2. Item A – Proposed Site Development Plan For Conifer Westminster Way, LLC, (Westminster Way Apartments)
   Item A – Proposed Site Development Plan for Conifer Westminster Way, LLC, (Westminster Way Apartments)

Subject: Proposed Site Development Plan for Conifer Westminster Way, LLC

Conifer, represented by Maser Consulting P.A., has applied for review of a proposed Site Development Plan (S-19-0012) for the Westminster Way Apartments, which contains 35 multifamily units and ground floor parking. The site consisting of the five parcels referenced above are zoned R-10,000 Residential and have been designated in the Compatible Neighborhood Overlay Zone as part of case LMA 19-01. Please note that a plat has been submitted to the City for lot consolidation and the approval of this plat is listed as a condition to site plan approval below.

SHEET TITLE:
EXTERIOR ELEVATIONS

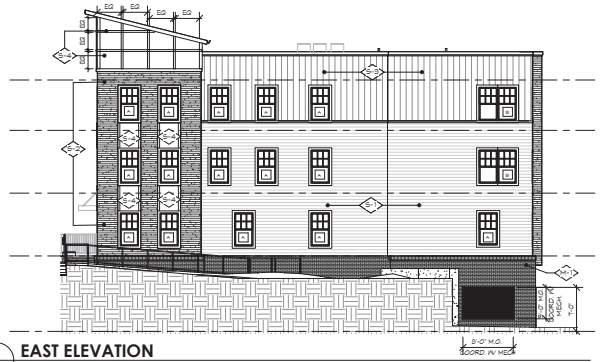
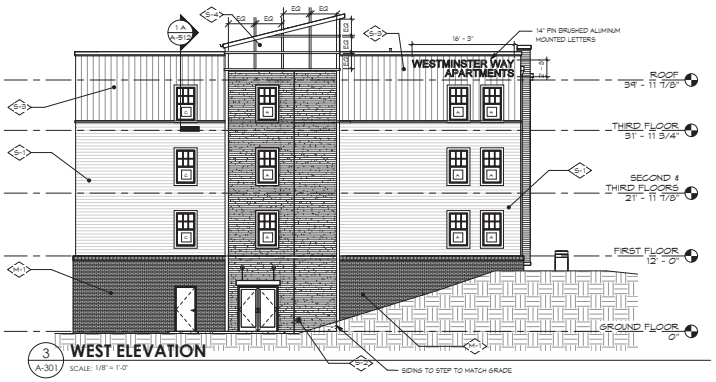
Modification of Adopted Preferences (2016 Development Design Preferences Manual)	
Standard	Staff Comment
Per page #25, Including building elements of various heights within the overall project design is encouraged	Please add varying heights similar to what is provided for on the West Main Street frontage.

Per page #27, Roof-lines should be segmented and varied within an overall horizontal context. Varying heights are encouraged	Please add varying heights similar to what is provided for on the West Main Street frontage.
The City prefers that loading docks, trash collection areas, outdoor storage and similar utility facilities and functions be incorporated into the overall design of the site. These facilities should be shielded from the public eye and kept out of view of adjacent properties and streets.	Please provide screening around the proposed transformer that will not interfere with the underground utilities.

The building has varying context as designed with different materials at the north and south elevations including two colors of concrete siding, one color of vinyl siding run horizontally, one color of siding run vertically, brick as well as paneling at the towers and at the bump outs. If further varied context (siding/façade) is required, please consider a modification request for this

design preference. (Color elevation is attached to this request, and we are providing a view from all sides for Planning Commission if not sooner)

The building has varying heights on all sides with the book end towers on the far east and west sides providing relief to the east and west elevations. However due to the solar panel collector design, we do not believe any further building height modification can be achieved.
